A COOPERATIVE STRATEGY FOR RESOURCE MANAGEMENT & PROTECTION

September 23, 2016

Subject: “Comment Letter – Calleguas Creek Metals TMDL Revisions.”

Figure 1. Camarillo Effluent Copper Concentration (2010-2015)

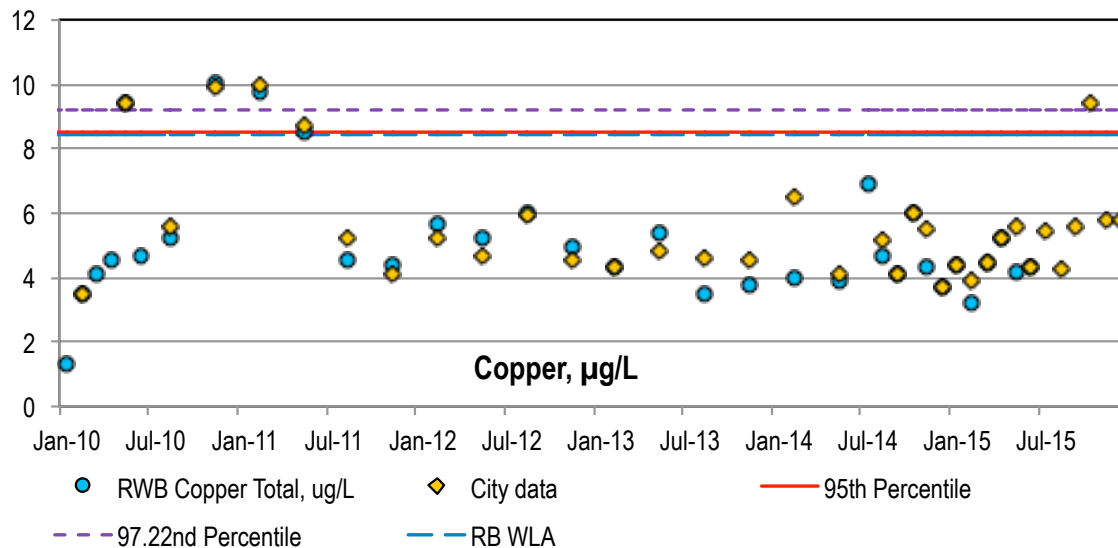
While the approach of setting allocations based on current effluent concentrations is appropriate, the values selected to be representative of current performance results in the proposed WLAs being overly protective and presenting potential compliance problems for the POTWs. An alternative approach is presented below that is consistent with available guidance and ensures continued protection of beneficial uses.

Data for each facility are compared to the proposed WLAs in Figures 1 and 2. Both facilities may have difficulty consistently complying with the proposed WLAs. The approach used assumes that the 95th percentile is the appropriate value for setting a WLA or effluent limit and that the data set has a normal distribution. Using the 95th percentile is not the only option available for reflecting current performance and puts the dischargers at risk of violating the WLA even though receiving waters are meeting objectives. As discussed below, an alternative calculation method, such as the maximum value as used in the Tentative Malibu Creek TMDL Implementation Plan, or a 97.2 percentile value is consistent with the guidance developed by EPA for calculating effluent limits and would present less compliance risk for the POTWs. Additionally, the data do not appear to be normally distributed.

Requested modification: Modify the average monthly WLA for copper to maximum observed concentration of 10 µg/L (or 97.22 percentile concentration of 9.8 µg/L) for Camarillo and 8.3 µg/L (or 7.6 µg/L) for Hill Canyon and adjust the mass-based allocations accordingly.

Figure 3. Dissolved Copper Concentrations in Watershed Discharges as Compared to Mugu Lagoon Concentrations

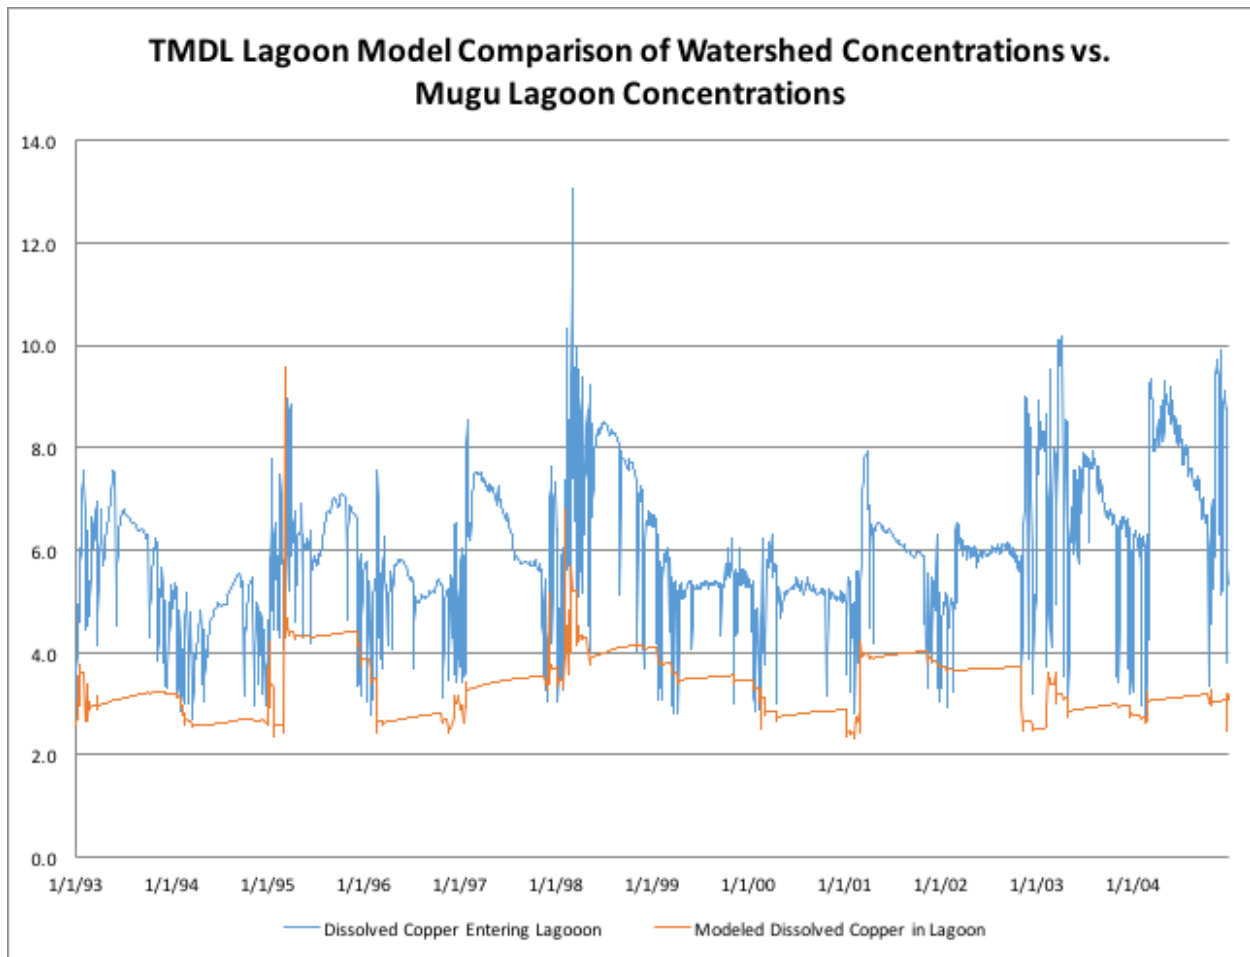
The modeling conducted for the TMDL development demonstrated that dilution was occurring in Mugu Lagoon which supported allowing higher loads in discharges upstream of the Lagoon. Figure 3 shows model results from the TMDL development that showed that concentrations in Mugu Lagoon (orange line) were (with one exception) always lower than concentrations entering the Lagoon from the combined flows of Calleguas Creek and Revolon Slough (blue line). Further analysis of the flow entering the Lagoon subsequent to TMDL development using the model indicates that approximately 38% of Mugu Lagoon inflow comes from Calleguas Creek resulting in a dilution factor of approximately 2.6. The WER of 3.69 is only 2.4 times higher than the WER of 1.51, which is less than the estimated dilution factor for flows from Calleguas and Conejo Creek into Mugu Lagoon. This indicates that discharges meeting an allocation calculated using a WER of 3.69 would not cause exceedances of the objective in Mugu Lagoon.

When the TMDL was developed, the urban and agricultural allocations were calculated based on estimating the mass loading from these discharges that would be needed to ensure that objectives were being met in Mugu Lagoon. The equation used to calculate the load-based allocations accounts for the watershed processes that occur between the discharge point and Mugu Lagoon and is not simply equal to the water quality objective multiplied by the applicable flow rate as was done in many TMDLs. Therefore, using 3.69 to calculate the loads is not equivalent to allowing discharges concentrations to equal the water quality objective multiplied by 3.69. As shown in the tables below, current loads from urban and agricultural dischargers are above the allocations calculated using a WER of 3.69. However, as discussed in the Draft Staff Report, the analysis of current conditions demonstrates that at the current loading from agricultural and urban dischargers, Mugu Lagoon is meeting the water quality objectives. In fact, the concentrations in Mugu Lagoon are approximately half of the objectives even though there are still some exceedances of allocations being observed and Revolon Slough is still exceeding objectives. If current loading from agricultural and urban dischargers are resulting in the objectives being met in Mugu Lagoon, and the current discharges are above an allocation calculated using a WER of 3.69, there is no evidence that using a WER of 1.51 to calculate the

Requested modification: Modify the footnote to the final WLAs for permitted stormwater dischargers and final LAs for agricultural dischargers as follows:

The approved site-specific WER of ~~1.51 for Mugu Lagoon~~ 3.69 for Calleguas Creek is used to calculate the assigned WLAs for discharges to Calleguas and Conejo Creek ~~to ensure the downstream standard is achieved.~~
